File 1981-0059

Project Name: First Security Savings and Loan Assoc. - Rezone RMF 32 to P Amendment to Final Plan

REVIEW SHEET SUMMARY

First Security Savings & Loan Facility
Response to:
Review Sheet Summary

SITE PLAN

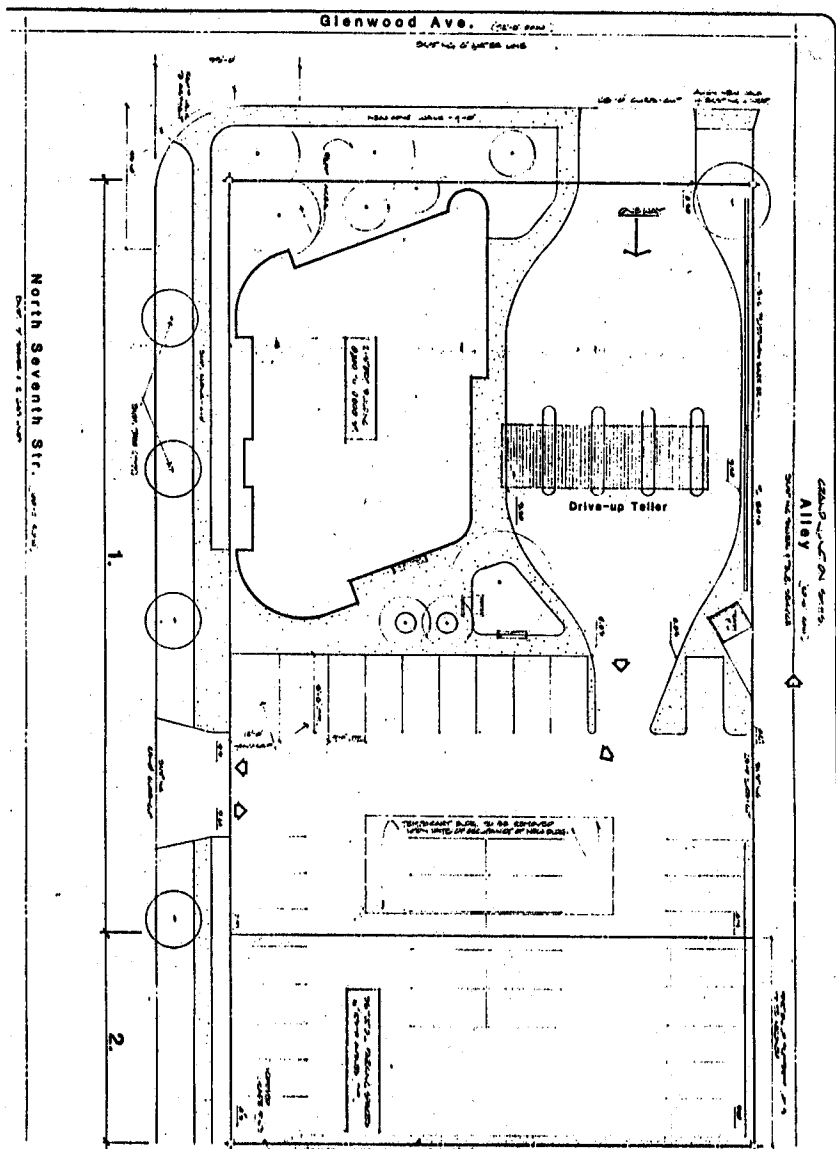
<u>DATE REC.</u>	<u>AGENCY</u>	<u>COMMENTS</u>
5/12/81	City Fire Dept.	We cannot accept this as a final. We need a fire flow done on this building. To do this we need square footage type of construction and distance to exposures. Also we need existing hydrant locations and proposed hydrant locations with line sizes. With this information we will be able to determine if you have adequate fire protection.
5/18/81	City Utilities	None.
5/18/81	Mountain Bell	Existing 20' utility easement in alley on the west side of property will be sufficient for our use.
5/18/81	Transportation Engineer	The overall traffic circulation and parking concept is O.K. while access to alley's by businesses is not generally desirable, the character and existing use of this alley would not be affected by the bank. With regard to the temporary structure, it's location is not compatible with parking layout, as shown. The structure encroaches into the aisle and reduces needed maneuvering space.

5/18/81	City Engineer	Final Development Plan looks good from standpoint of driveway locations and sizes, public sidewalks and the proposed planter and curbing to define and somewhat control that alley at Glenwood. All driveway and sidewalk work in the streets rights-of-way must be according to City Standard Drawing ST-1 and will require a permit issued to a licensed concrete contractor by the City Engineer's office.
5/18/81	Staff Comments:	<p>Check if mobile unit has drive up windows? (drive-up policy).</p> <p>North portion permanently landscaped in phase I. Is drive-up canopy part of temp. or perm. bldg.</p> <p>Alley access in question - (what impact on 7th & Glenwood).</p> <p>Bushies at entry off of 7th - no blocked views.</p> <p>Need dimensions/ht./scale of perm. bldg.</p> <p>Future parking area unclear.</p> <p>Ht./Dimensions of canopy bldg.</p> <p>Fire access thru drive-up.</p> <p>Trash p/u needs to be indicated.</p> <p>Need phasing.</p> <p>Employee parking.</p> <p>Internal circulation on final plan in question (should enter on 7th, exit on Glenwood).</p> <p>Left turn on to 7th needs impact statement.</p> <p>Fits 7th St. policy.</p> <p>Lighting needs to be shown.</p> <p>Previously approved for 12,000 sq. ft. - now 8 - 10,000 sq. ft.</p> <p>Need bike racks</p>

Signage needs to be shown.
Improvements guarantee for sidewalks.
Commitment letter with time of removal of
temp. bldg.

<u>DATE REC.</u>	<u>AGENCY</u>	<u>COMMENTS</u>
	Staff Comments	1) How will landscaping be maintained? Any way to preserve existing vegetation? 2) Will the screen fence to the north be an adequate buffer? 3) What is a pedestrian barrier - (need detail)? 4) Any bike racks provided? 5) Need trash pick-up coordinated with Sanitation Dept. 6) Handicap parking space designated as such. 7) Parking stalls next to curb cut off 7th in question - too close to entry. 8) 1 space next to alley in question - backing into ingress/egress. 9) Employee parking to be designated. 10) Note with 10,800 square feet building - need 36 plus employee parking with some stalls in question may require smaller building. 11) Will need dimensions of proposed building - since this is a final, need exact height, elevation and dimensions. 12) Any neighborhood input? 13) Drive-up lanes should be designated. 14) Need detailed signage. 15) Has fire flow and fire access and fire hydrants been approved for drive-up and building? (see previous review comments). 16) Lighting detail needed. 17) How will the alleyway be impacted as a result of this proposal?

1/18/82	Staff Comments	1) This is a final plan and we need more details. 2) Parking lot broken up with more landscaping. 3) Better design and utilization for parking lot could be shown. 4) No existing utilities shown - need detailed utilities composit - this is a final. 5) Outdoor section lighting shown.

The aisle width will be increased by five (5) feet to comply with the minimum parking requirements.

The temporary modular structure will not provide drive-up service.

The entire area north of the building envelope will be permanently developed and landscaped.

There will be no access from the alley, only egress.

There will be no landscaping higher than thirty (30) inches at all vehicular ingress and egress points.

One bike rack will be provided.

Improvement guarantee for the sidewalk will be submitted with the final documents.
